Staff Briefing Papers

Company Northern States Power Company d/b/a Xcel Energy

Docket No. **E002/M-23-452**

In the Matter of Xcel Energy's 2023 Integrated Distribution Plan

Figure 11: Comparison of Xcel Distribution System Spending Projections: 2021 IDP, 2022 Compliance Filing, and 2023 IDP¹⁰⁶

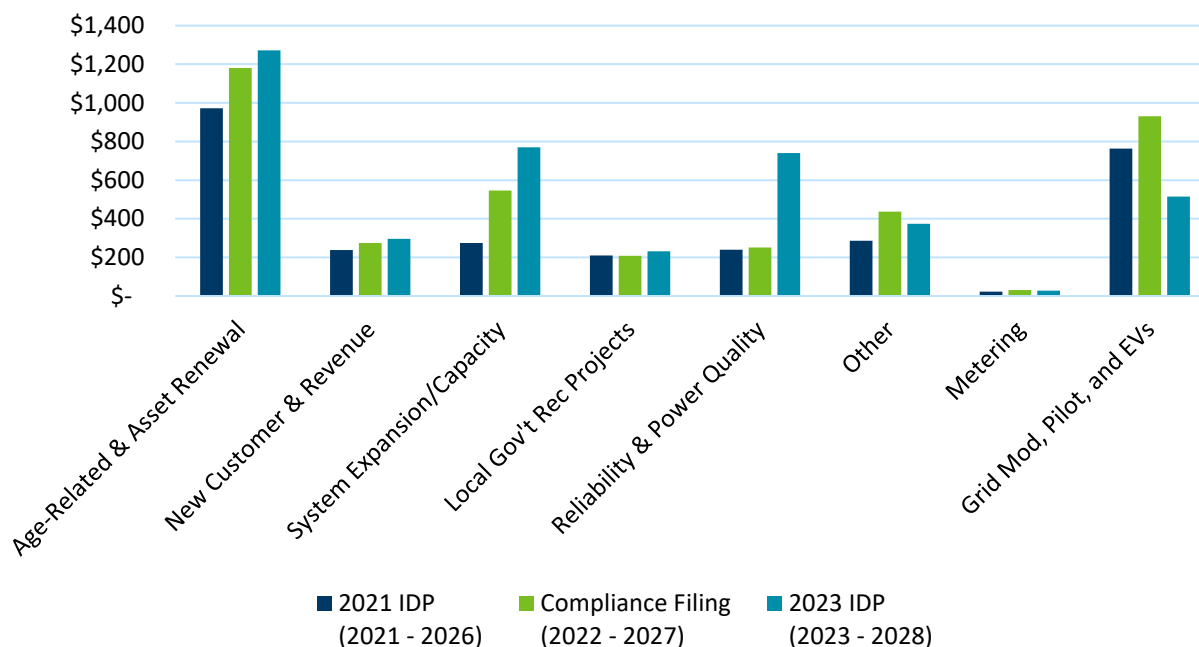
According to this review, the Department found the Company’s budget continues to increase above projections each year. The Company’s 2021 IDP projected total distribution spending was approximately \$3 billion between 2021 and 2026, but compliance filings showed spending increasing between the years 2021-2027 to \$3.9 billion. Now, in the 2023 IDP, the Company’s

projected total distribution budget between 2023 and 2028 is \$4.2 billion.¹⁰⁷ The Department notes primary budget category increasers are the Age-Related Replacement and Asset Renewal category, the System Expansion or Upgrades for Capacity category, and the System Expansion or Upgrades for Reliability and Power Quality category. Figure 12 depicts historic actual spending vs future projected spending across the IDP categories.

After review of this budget increase, the Department expressed concern over the limited visibility the Department has into the Company's total budget. Specifically, the Department expressed concern over the Company's lack of specificity on projects and programs in IDP budget category allocations. In the Age-Related Replacements and Asset Renewal spending category, the Company allocates funds according to blanket costs, program costs, and project costs. Such program and project are scattered throughout the IDP, but the Company does not provide specific differences between these spending categories. The Company also allocates over \$700 million in the Company's System Expansion or Upgrades for Reliability and Power Quality budget category and \$500 million of that budget was identified it as "All Other Programs." Due to the Company's broad language that covers large spending allocations, the Department recommends Xcel be required to separate its total budget into discrete, specific categories that increases transparency of the distribution budget.¹⁰⁹

Figure 14: Forecast of Upgrade Costs 2023-2052, for TPS and 50% Planning Limit Scenarios

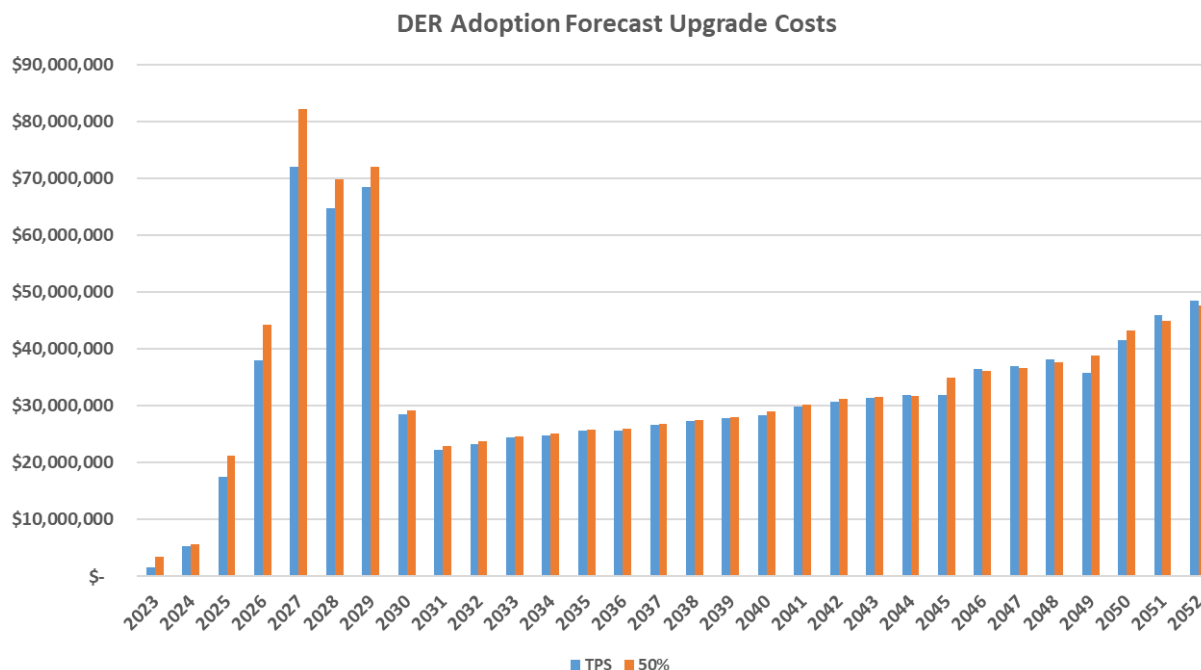
Staff notes that the 50% TPS, or the orange section in the above Figure 14, is an alternative TPS that Commission has denied so Staff recommends focus be placed only on the blue bars of the graph.
